Addendum Number: 03

Addendum Issue Date: April 28, 2025

Project Name: Robinson Washington Elementary
Renovation & Addition

Project Number: 02401781.001

SITE DETAILS

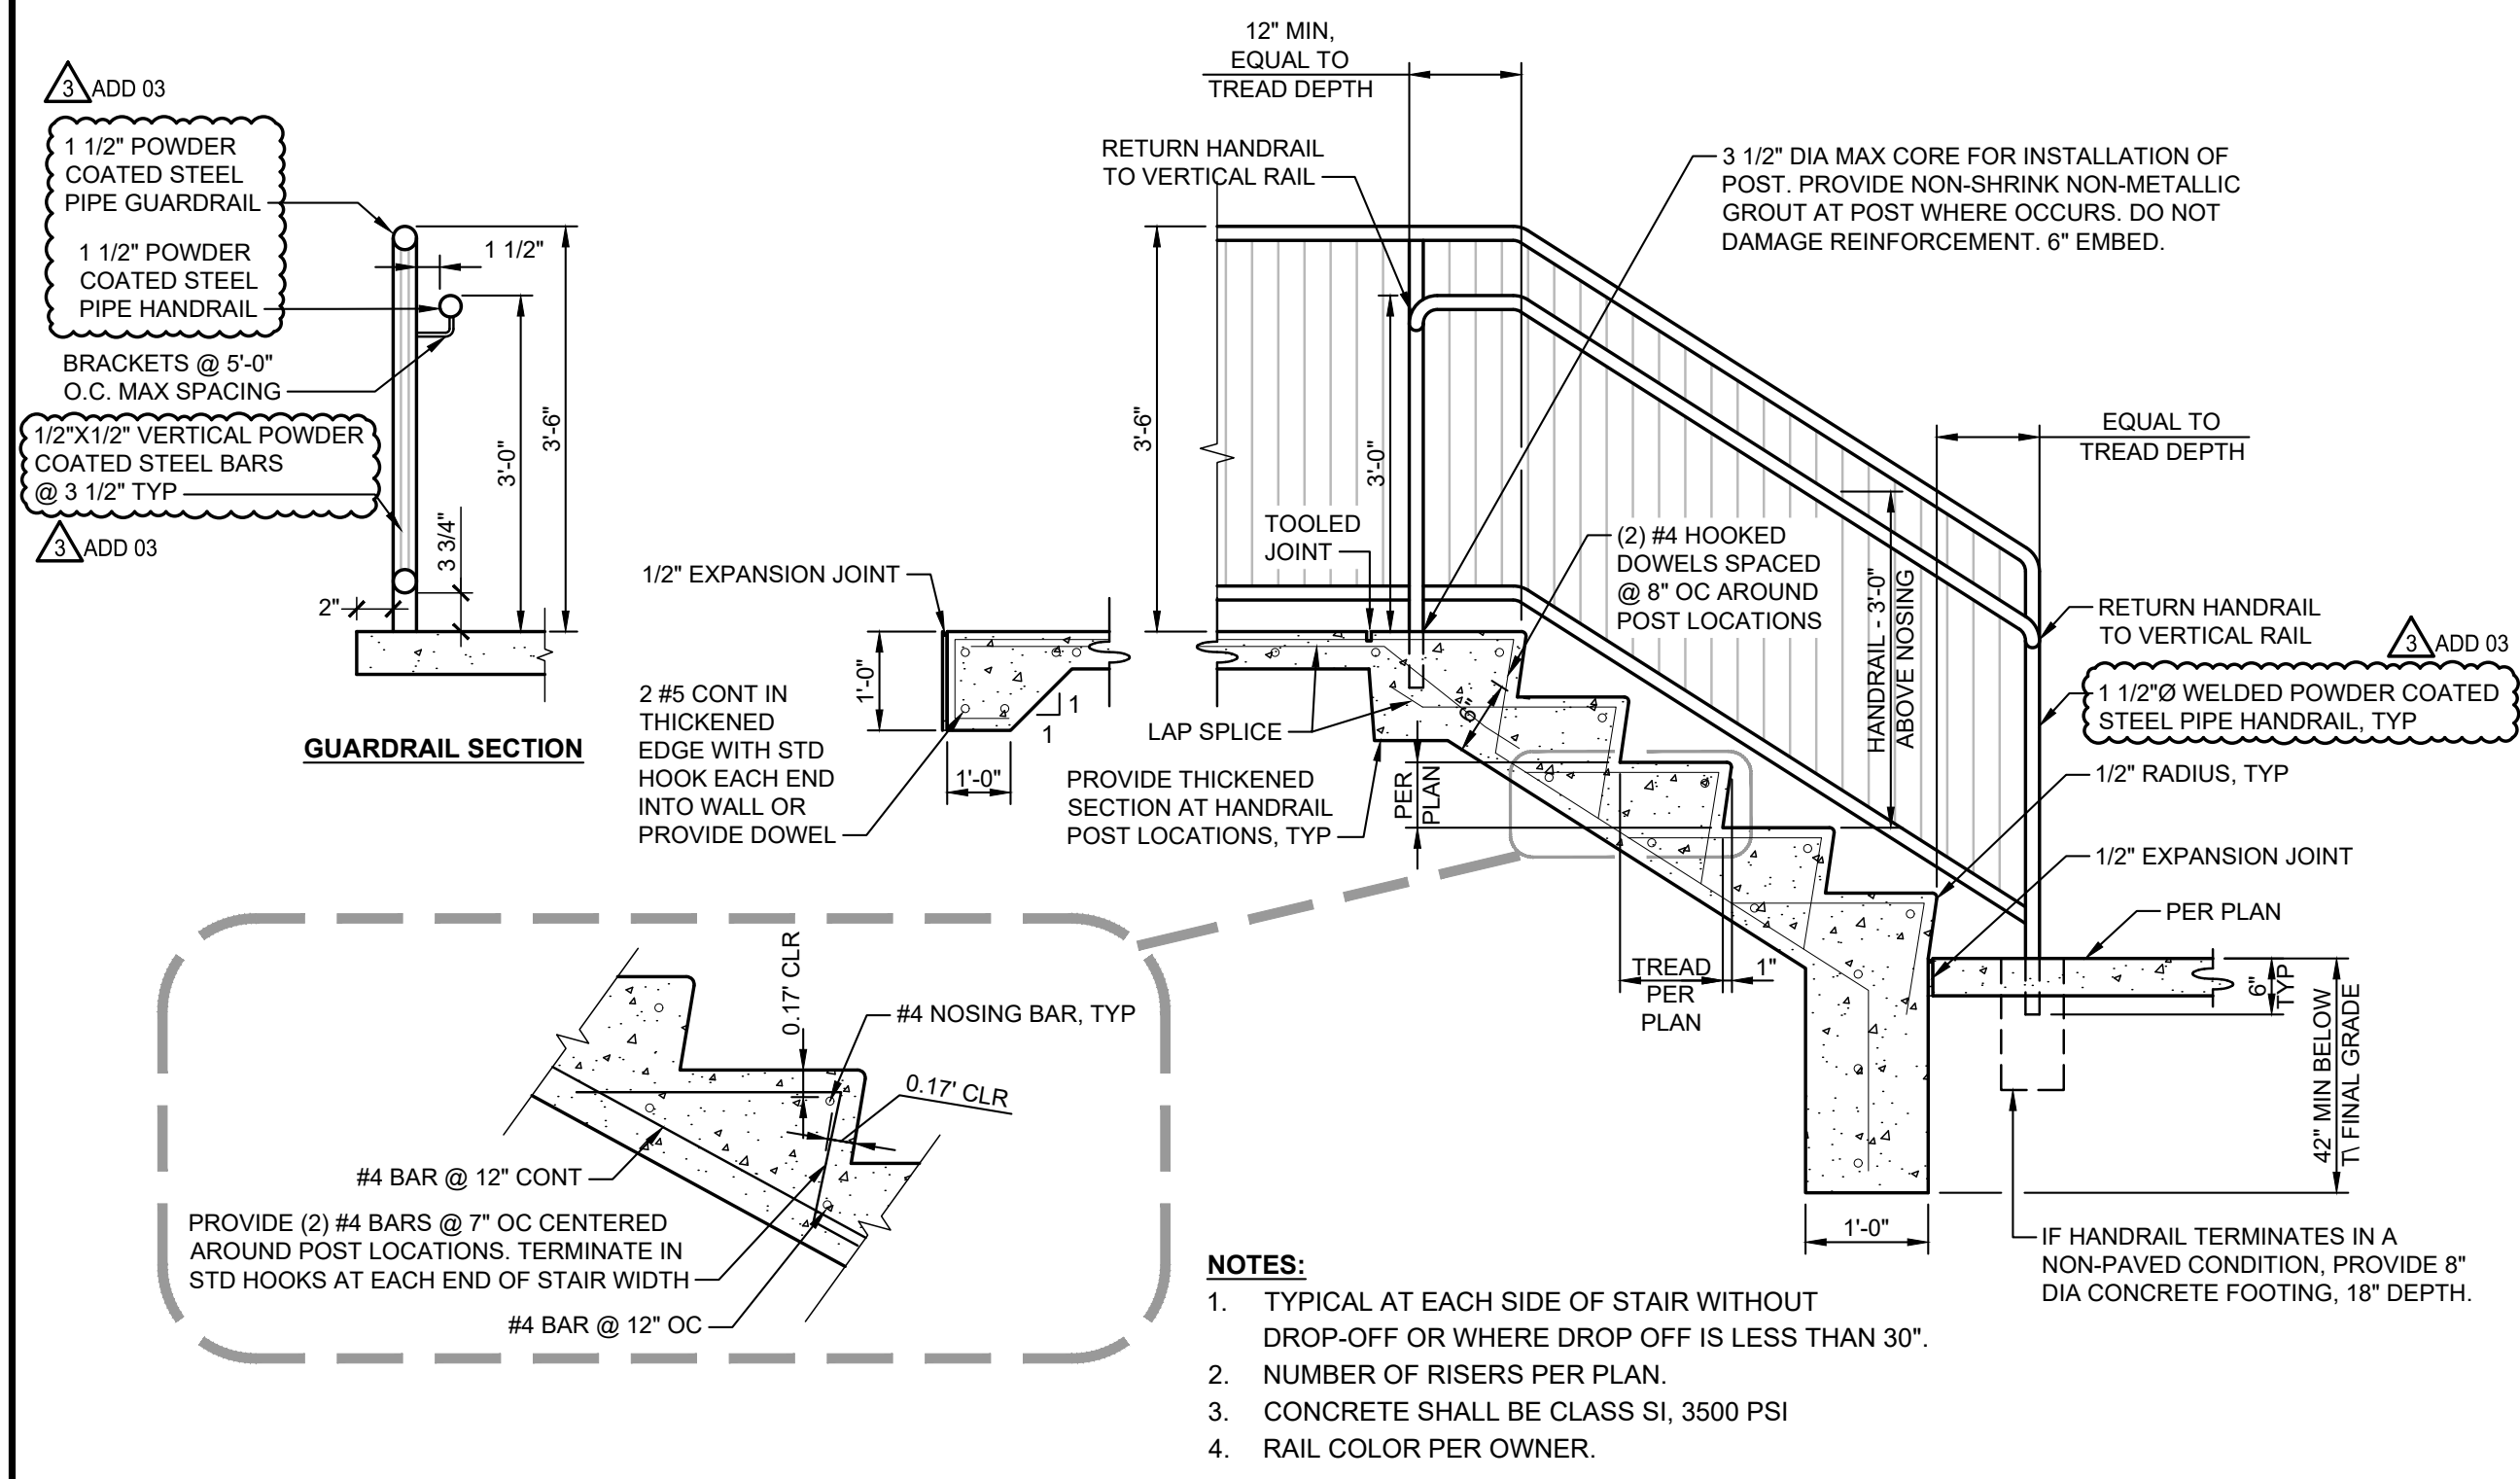
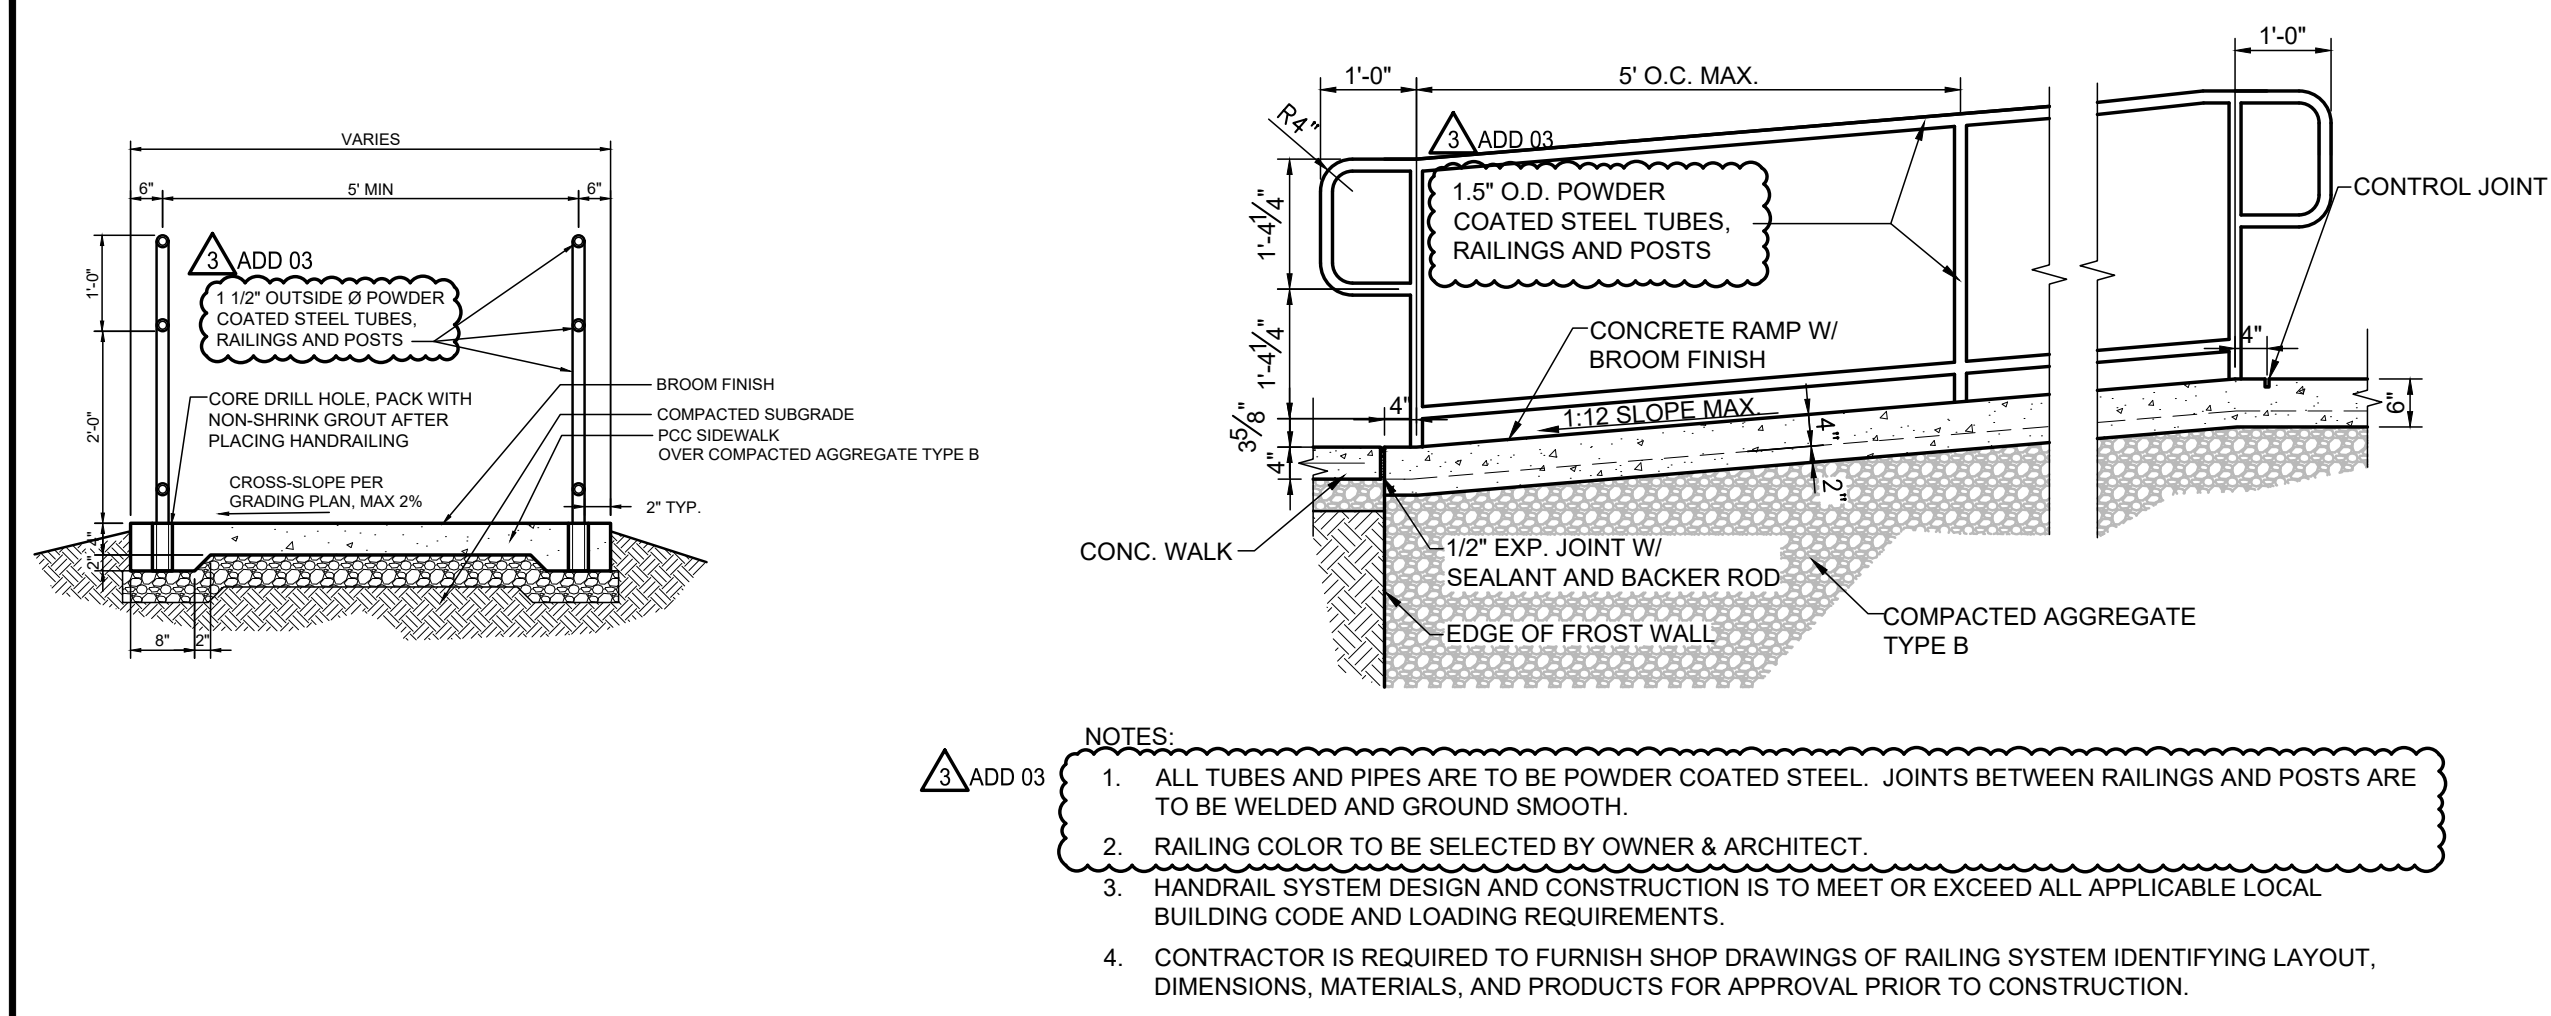
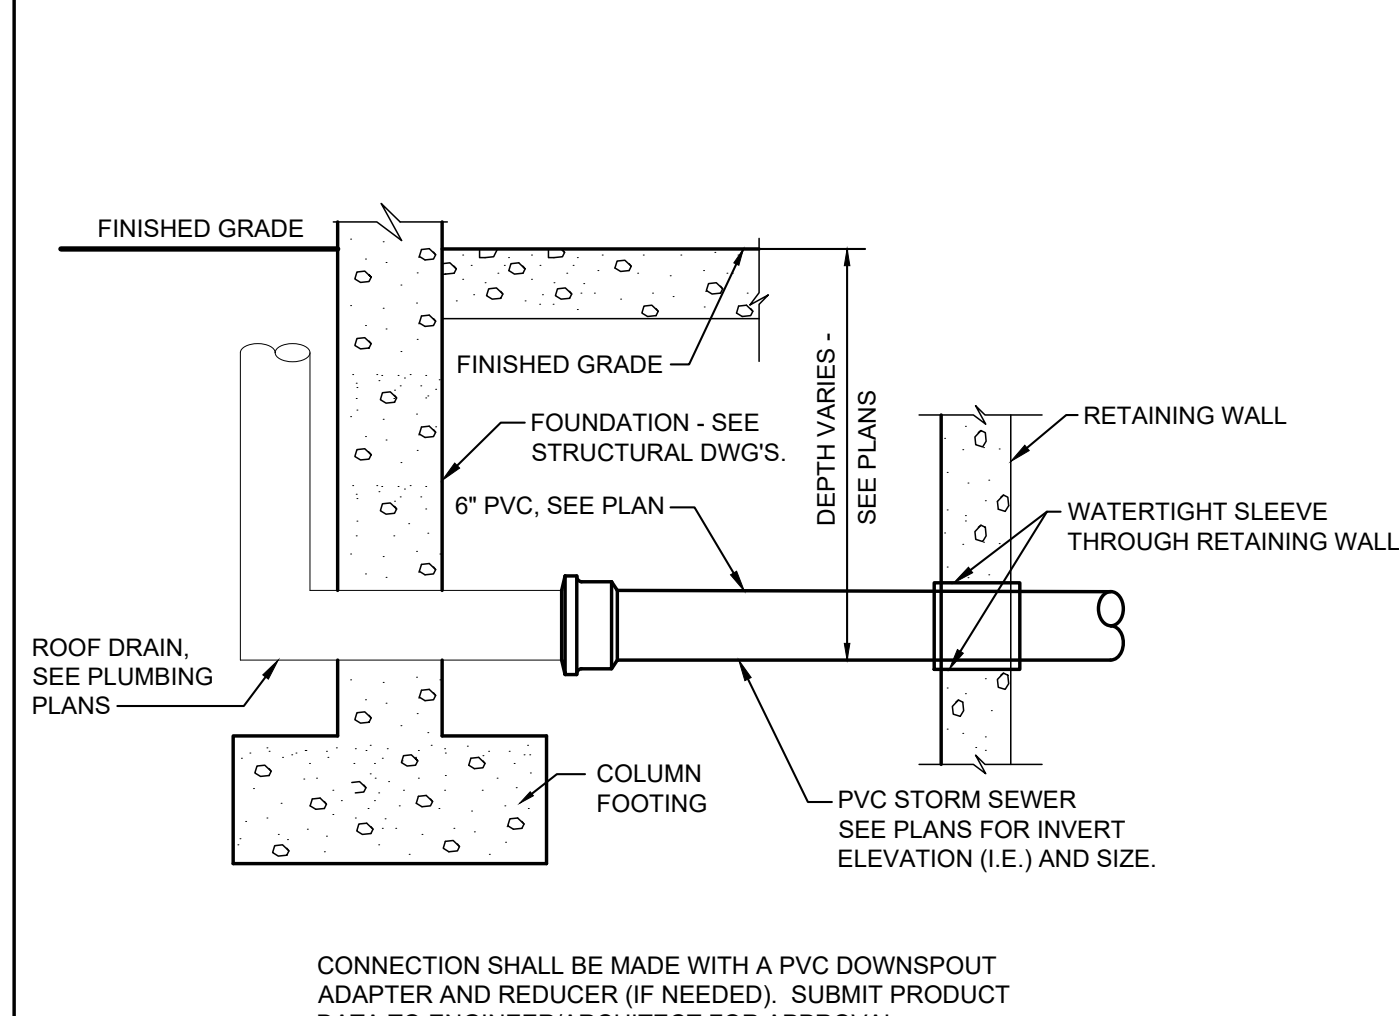
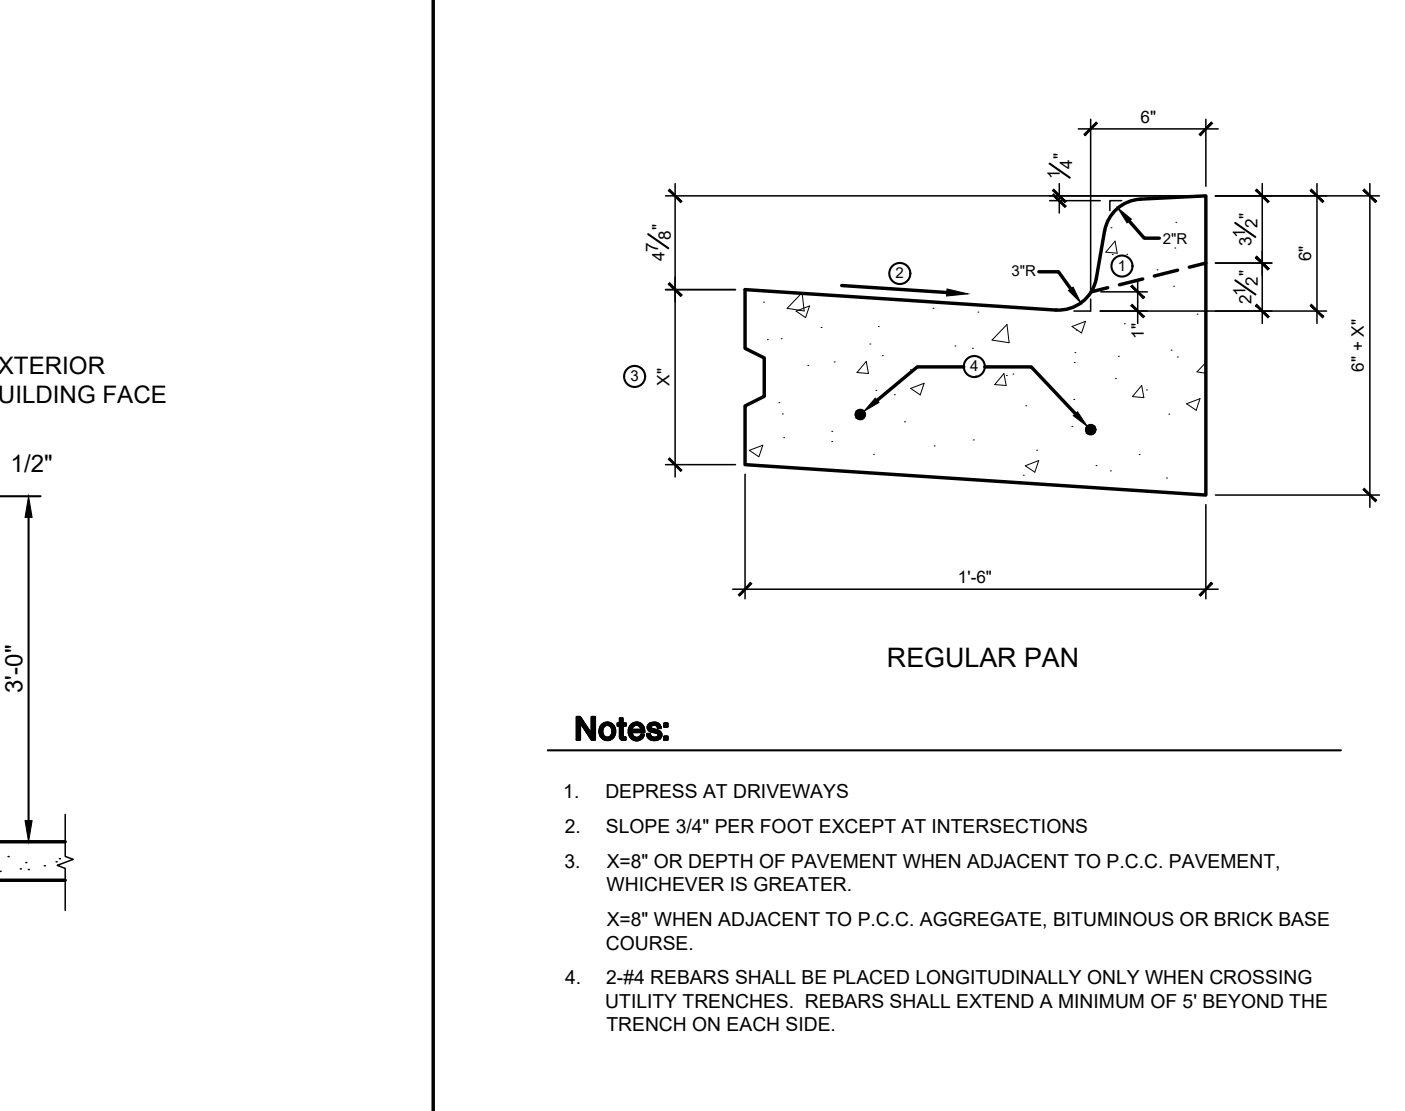
1. C1.1 – SITE & UTILITY PLAN
 - a. REMOVE color black specified for handrails/guardrails.
 - b. ADD note that handrail/guardrail color will be selected by the Owner and Architect.
2. C1.2 – SITE DETAILS
 - a. REVISE handrail material and color on Detail 1.
 - b. REVISE guardrail material and color on Detail 2.
 - c. REVISE handrail material and color on Detail 3.
 - d. REVISE handrail material and color on Detail 10.
3. S3.2 – FOUNDATION DETAILS
 - a. ADD protective steel coating below slab in Detail 11.
4. A5.9 – EXTERIOR DETAILS
 - a. ADD protective steel coating below slab to all the columns in the Gross Motor area.
 - b. ADD 2" rigid insulation to wrap around the columns.
